PROJECT NAME: Torrington WPCF Comprehensive Upgrade Project

SUBJECT: Addendum No. 2 for BID # WPU-041-040318

ADDENDUM NO. 2

**CITY OF TORRINGTON, CONNECTICUT
WATER POLLUTION CONTROL FACILITY COMPREHENSIVE UPGRADE**

CITY OF TORRINGTON, CT WATER POLLUTION CONTROL FACILITY COMPREHENSIVE UPGRADE	NO.	REVISIONS	DRAWN BY	APP'D
	1	ADDED SECTION 13 TO DWG S-25	RAO	MWC
	2			
PROJ NO: 13164 DATE: MARCH 2018	3			
WRIGHT-PIERCE Engineering a Better Environment	RFI #2 REFERENCE: DWG S-25			FIGURE: S1

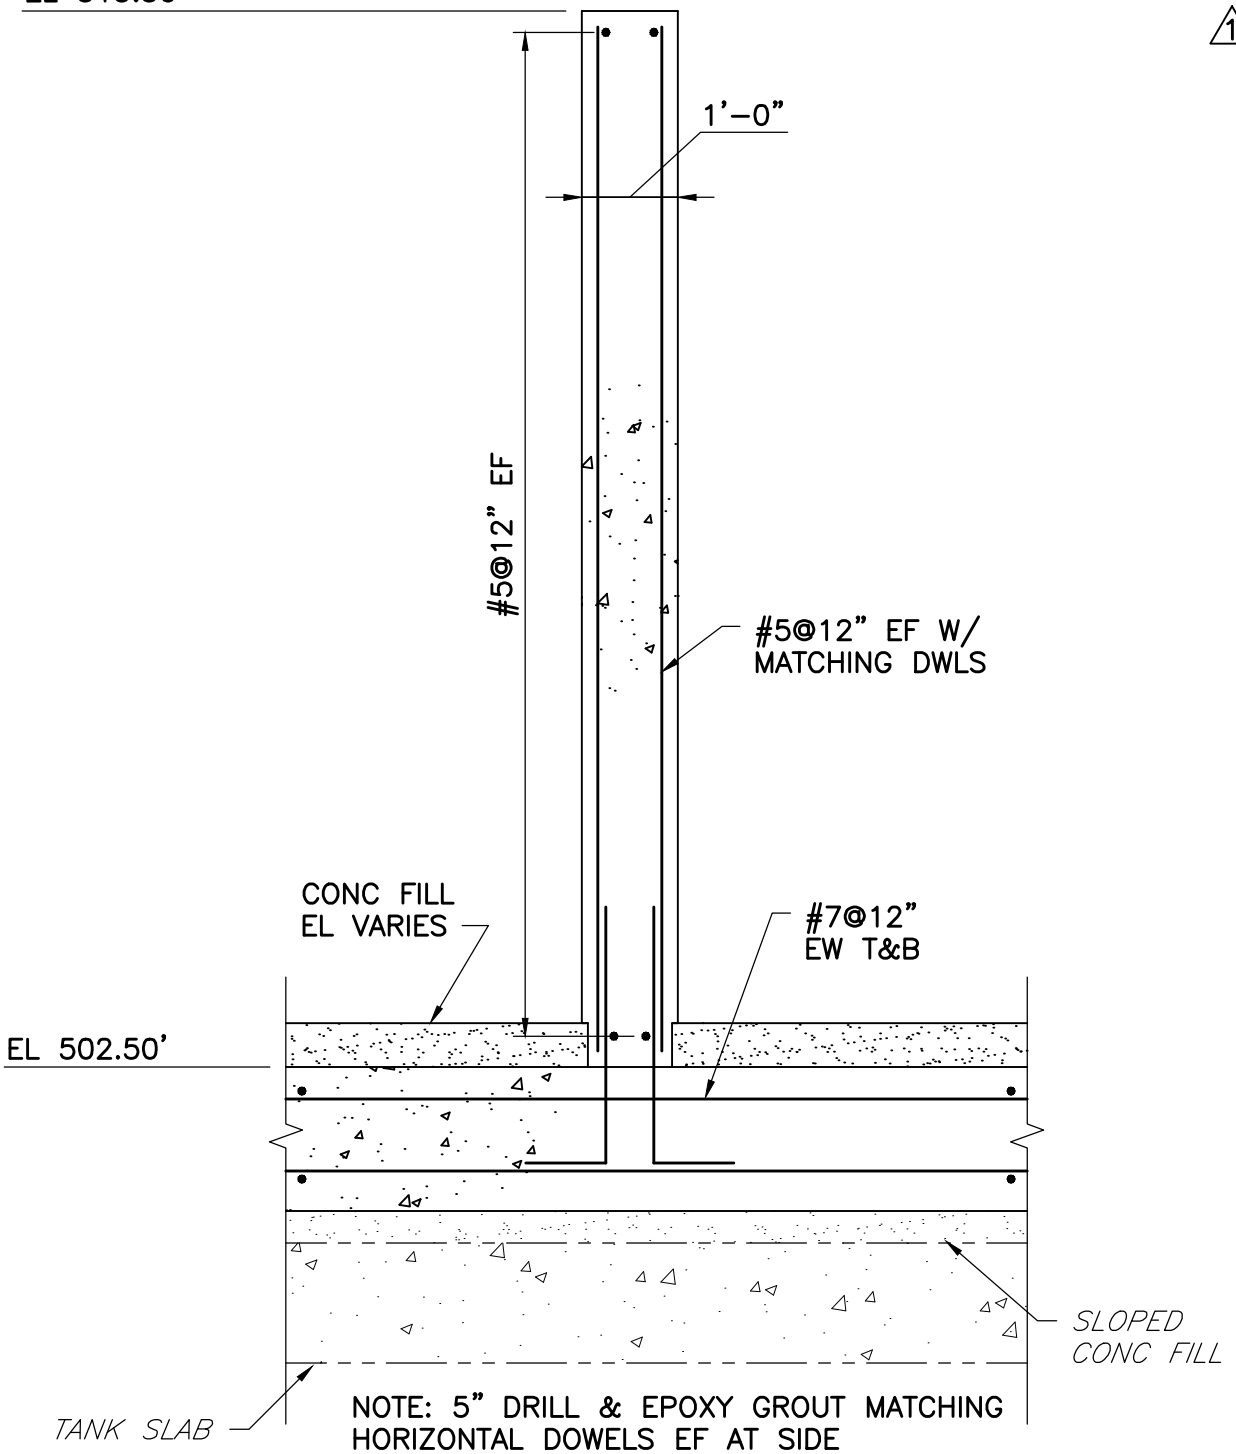
5. Drawing S-19: **DELETE** reference to section 13A / S-25.
6. Drawing S-25: **INSERT** Figure S-1 to include detail for Section 13 on the sheet.
7. Drawing S-46: **INSERT** the following new note to the Notes portion of the drawing:

6. Drawing S-19 has two sections labeled 13 and 13A with a leader to drawing S-25. The details associated with these sections are not shown on S-25 or the other Aeration Tank #1 structural drawings. Please provide these details.

Response: *Delete Section 13A from S-19. See Figure S-1 for Section 13.*

ADDENDUM NO. 2
REFERENCE: DWG E-135

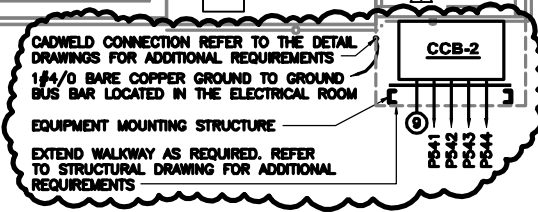
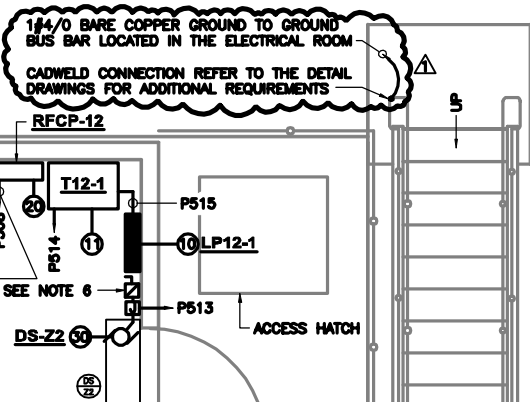
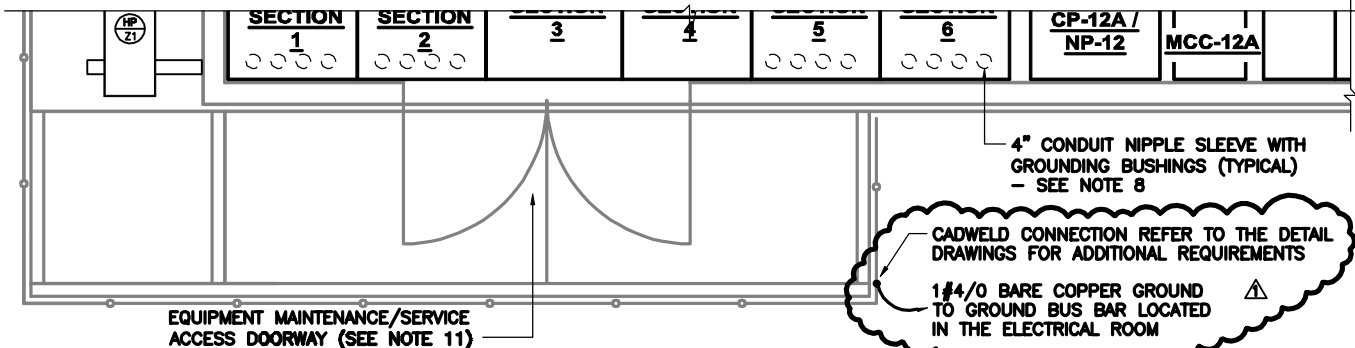
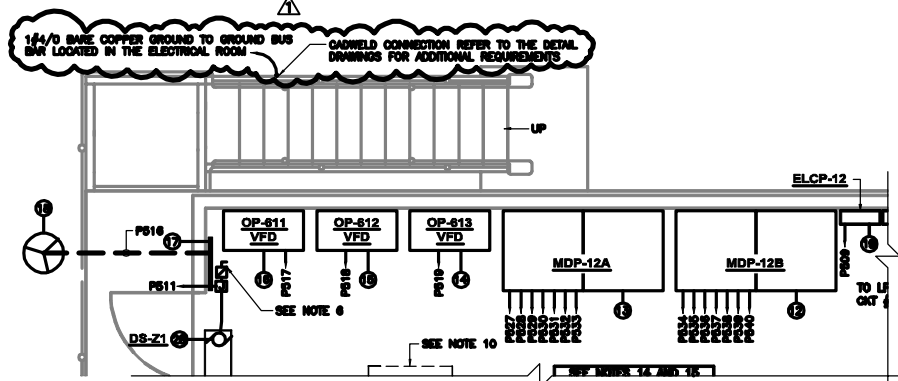
- c. The reason for removal is that this area will contain a high traffic demolition which makes it necessary for removal.”
35. Drawing E-135, **ADD** and **REVISE** the following clouded items shown on attached Figure E1:

- A. **ADD** grounding of both stairwells and platform at this location.
- B. **REVISE** location and mounting of Camlock Connection Box CCB-2.
36. Drawing E-91, **ADD** and **REVISE** the following clouded items shown on attached Figure E2:

CITY OF TORRINGTON, CONNECTICUT WATER POLLUTION CONTROL FACILITY COMPREHENSIVE UPGRADE	NO.	REVISIONS	DRAWN BY	APP'D
	1	ADDED STAIR GROUNDING. MOVED CCB-1		---
	2			
PROJ NO: 13164 DATE: MARCH 2018	3			
WRIGHT-PIERCE Engineering a Better Environment			ADDENDUM NO. 2 REFERENCE: DWG E-91	
			FIGURE: E2

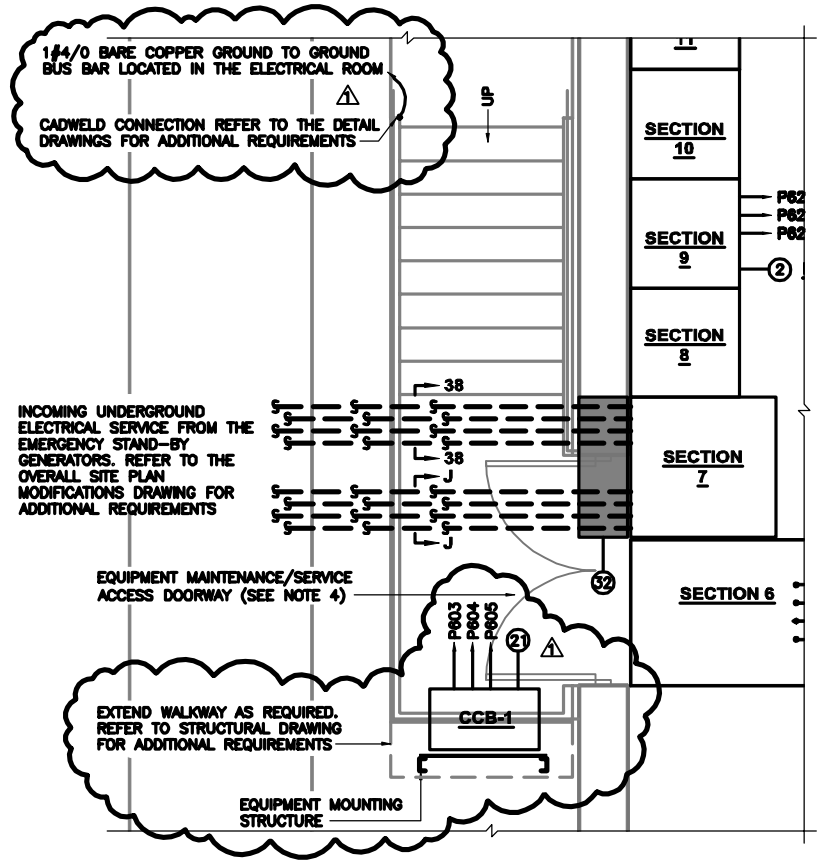
- A. **ADD** grounding of stairwell and platform at this location.
- B. **REVISE** location and mounting of Camlock Connection Box CCB-1.
37. Drawing E-91, **ADD** the following clouded items shown on attached Figure E3:

CITY OF TORRINGTON, CONNECTICUT WATER POLLUTION CONTROL FACILITY COMPREHENSIVE UPGRADE	NO.	REVISIONS	DRAWN BY	APP'D
	1	ADDED STAIR GROUNDING. MOVED CCB-1		---
	2			
PROJ NO: 13164 DATE: MARCH 2018	3			
WRIGHT-PIERCE Engineering a Better Environment	ADDENDUM NO. 2 REFERENCE: DWG E-91			FIGURE: E3

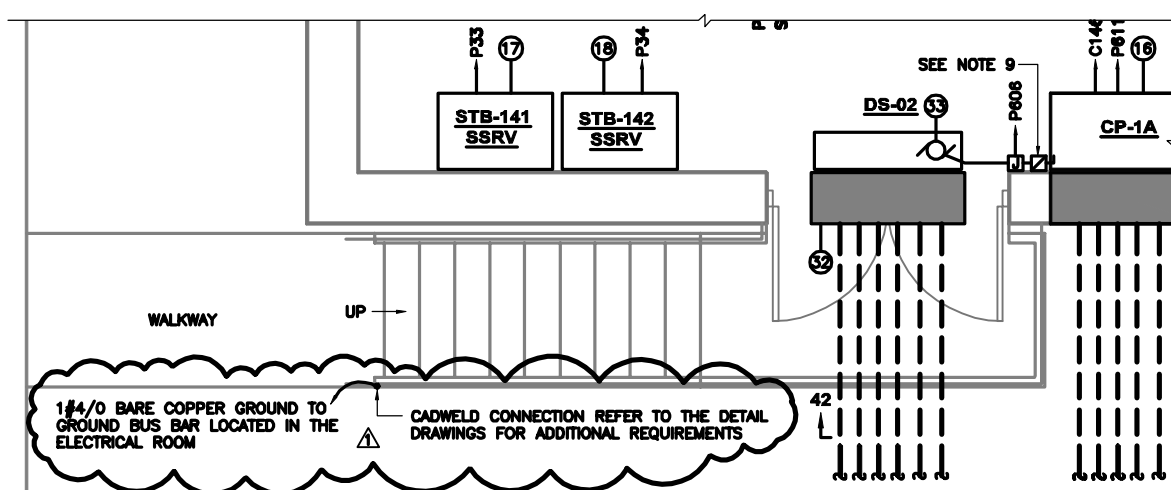
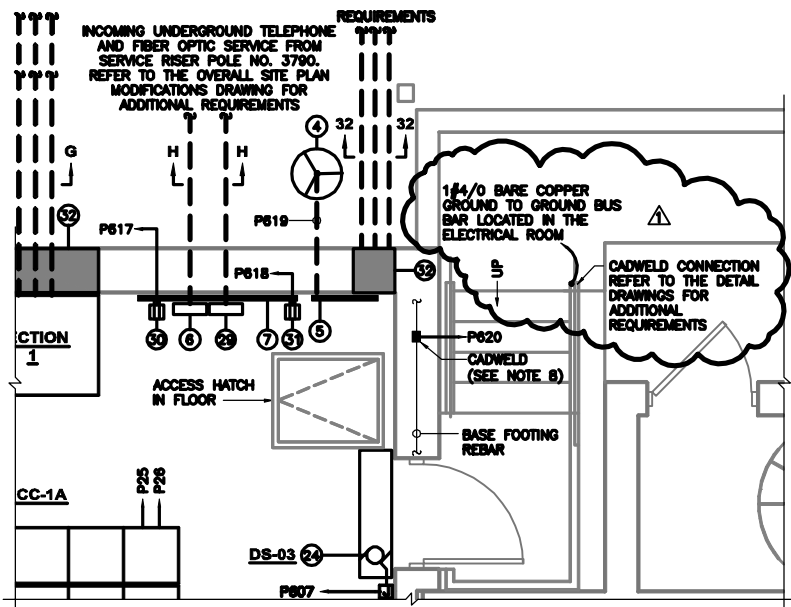
- A. **ADD** grounding of stairwell and platform at this location.
38. Drawing E-104 **ADD** the following clouded items shown on attached Figure E4:
- A. **ADD** grounding of stairwell and platform at this location.

CITY OF TORRINGTON, CONNECTICUT WATER POLLUTION CONTROL FACILITY COMPREHENSIVE UPGRADE	NO.	REVISIONS	DRAWN BY	APP'D
	①	ADDED STAIR GROUNDING		---
	②			
PROJ NO: 13164 DATE: MARCH 2018	③			
WRIGHT-PIERCE Engineering a Better Environment	ADDENDUM NO. 2 REFERENCE: DWG E-115			FIGURE: E5

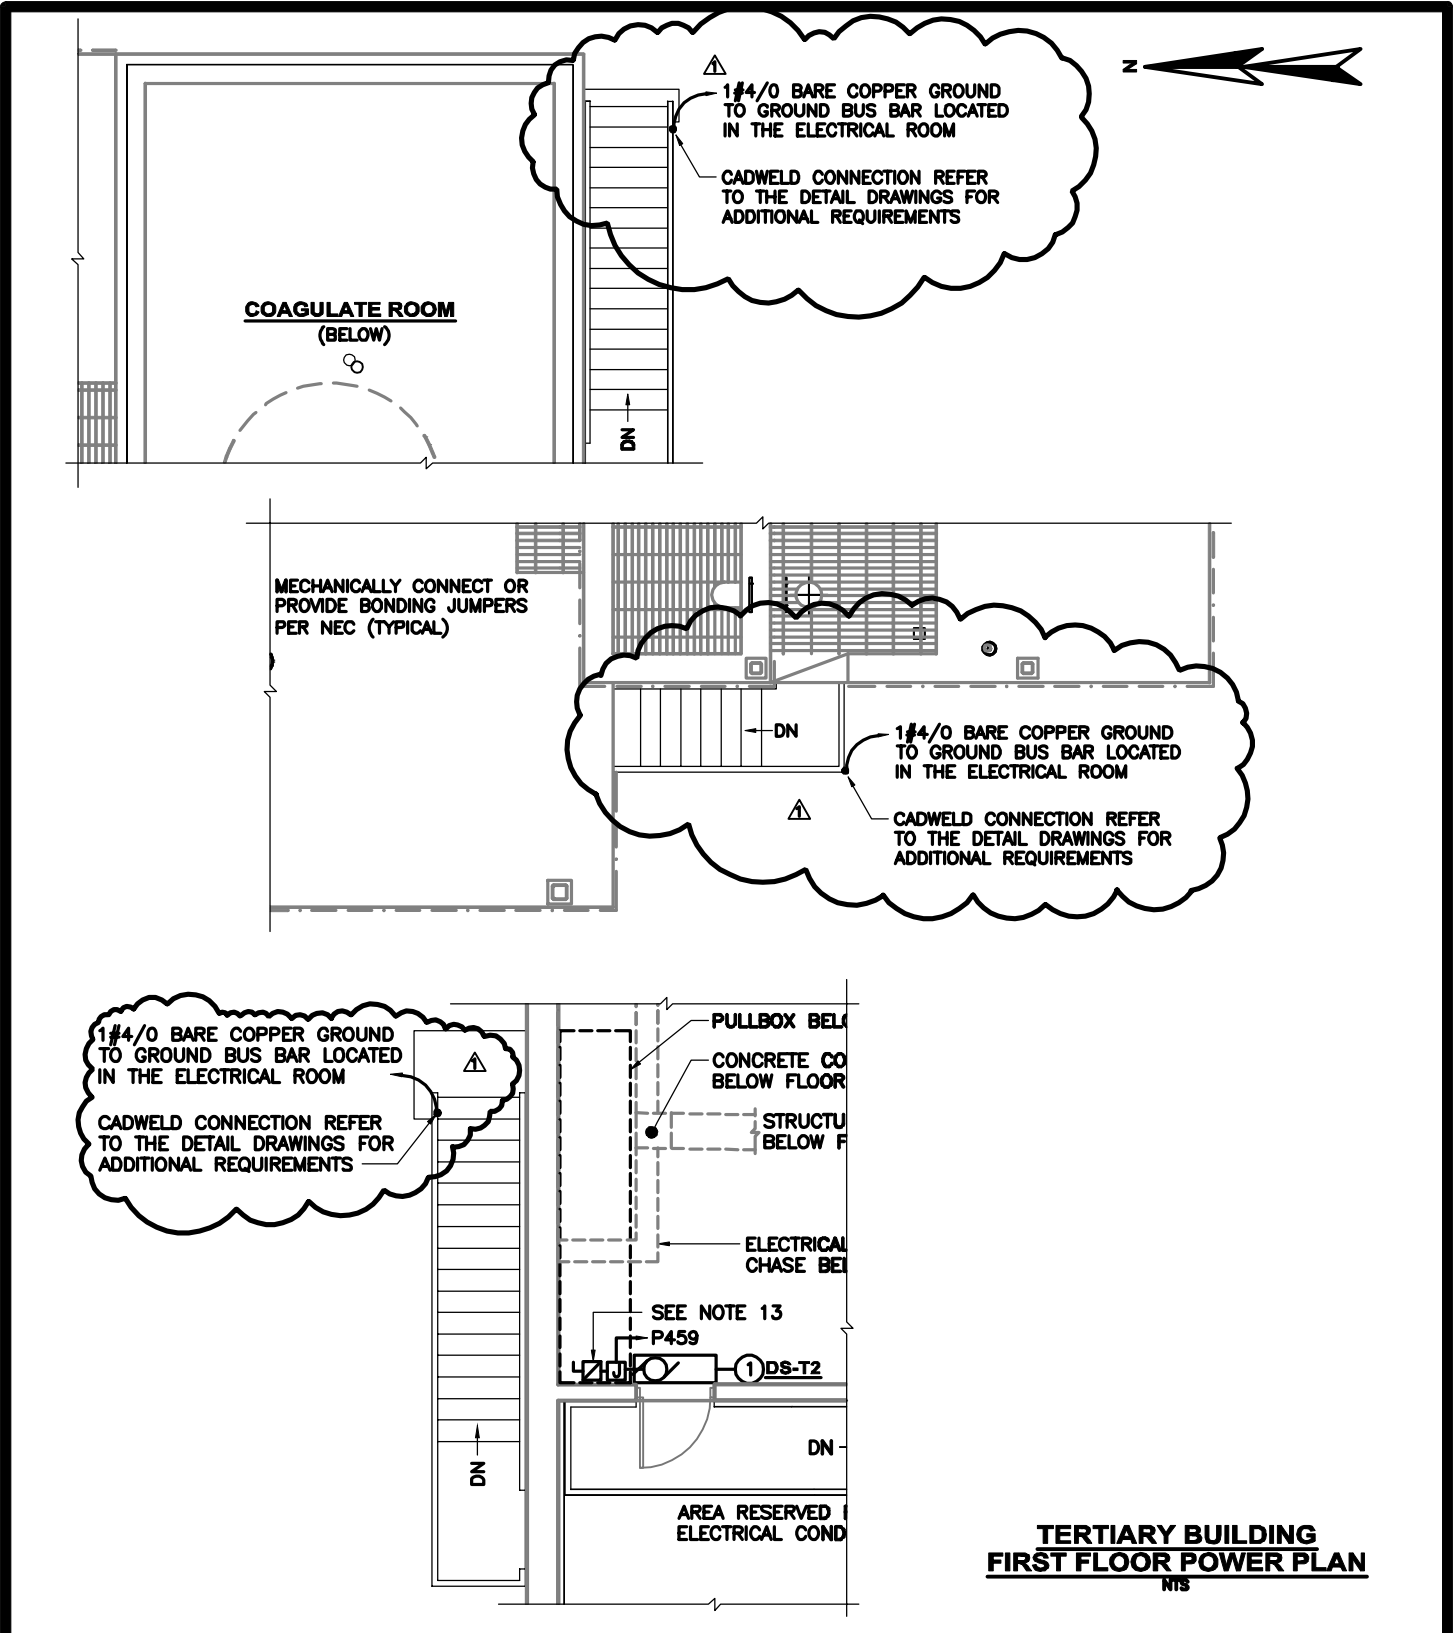
39. Drawing E-115, **ADD** the following clouded items shown on attached Figure E5:
- A. **ADD** grounding of stairwell and platform at this location.
40. Drawing E-89, **CLARIFY** the following clouded items shown on attached Figure E6:

ADDENDUM NO. 2
 REFERENCE: DWG E-89

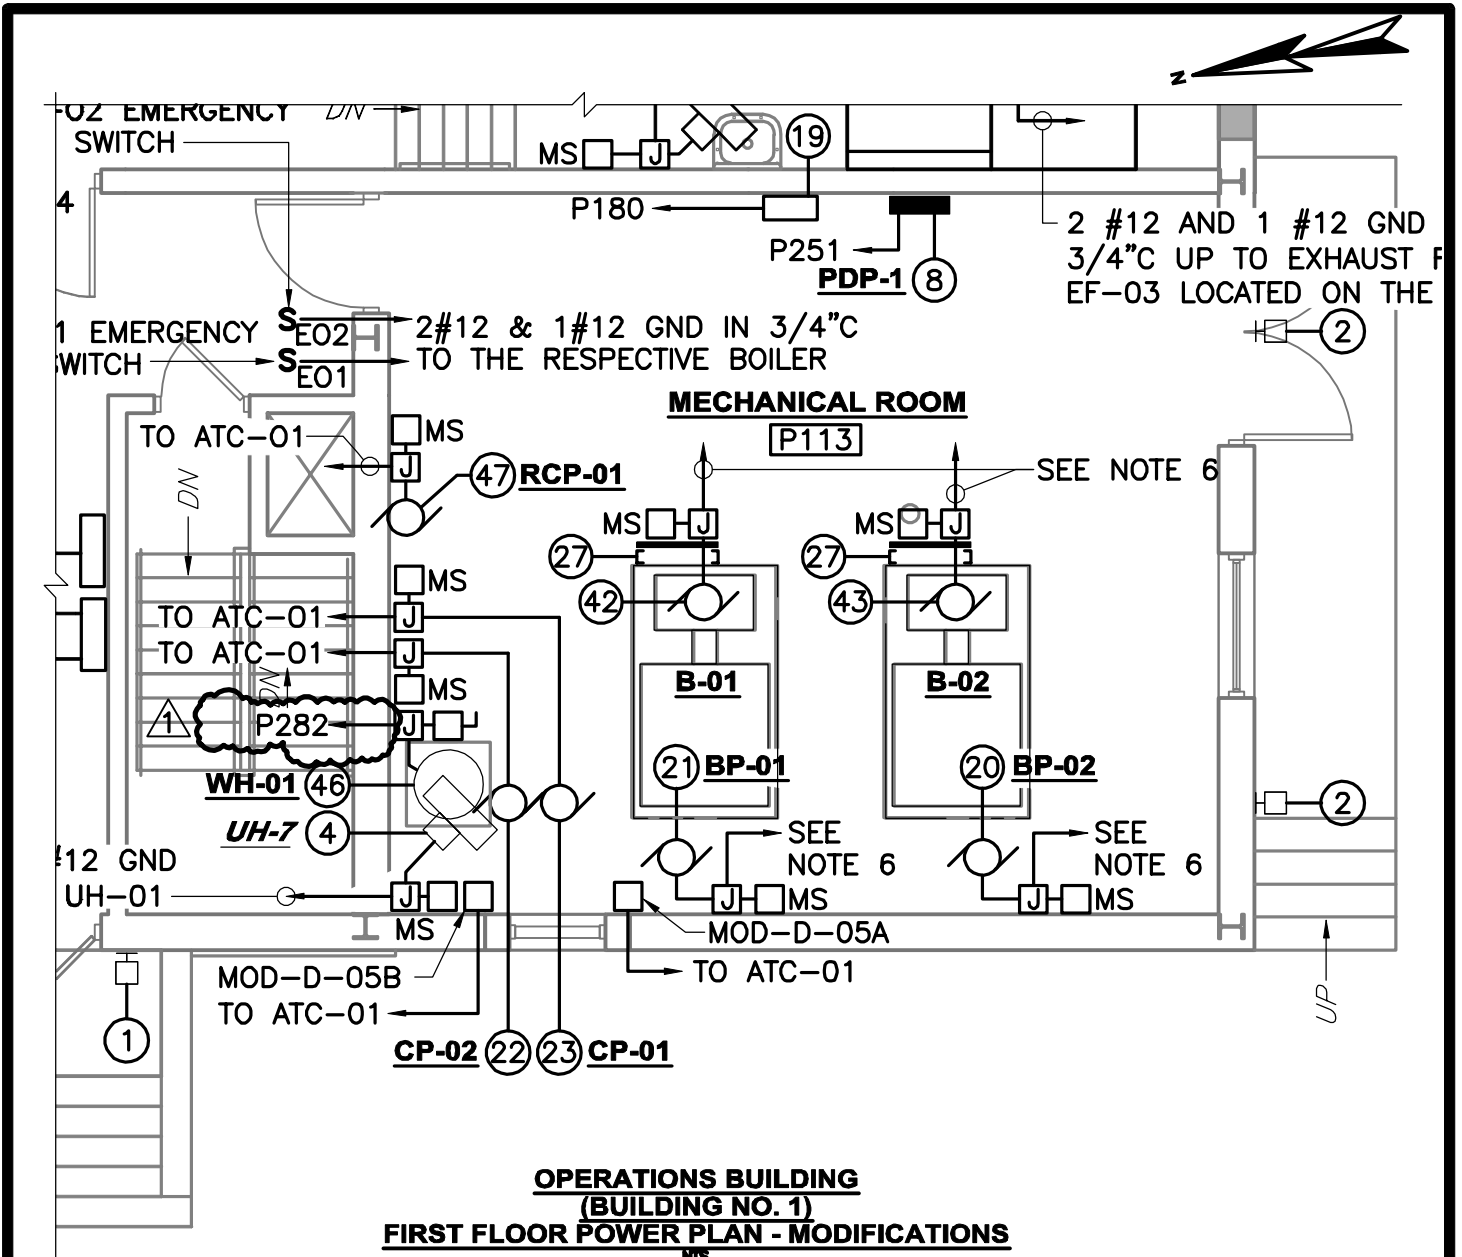
- A. **CLARIFY** conduit run to show P282 as this was overwritten on the existing drawing.
41. Drawing E-167, **ADD** the following clouded items shown on attached Figure E7:
A. **ADD** conduit and wiring shown to the respective dewatering Control Panels CP-1B and CP-1C.
42. Drawing E-191, **ADD** seal water solenoid valve and CRX interlock similar to the return sludge pumps shown on drawing E-192 for the effluent water pumps.
43. Drawing E-113, **ADD** seal water Solenoid Valves SV-6201, SV-6202, and SV-6203 next to the respective effluent water pump.
44. Drawing E-190, **ADD** auxiliary contact CR5 for high high torque alarm to PLC input.
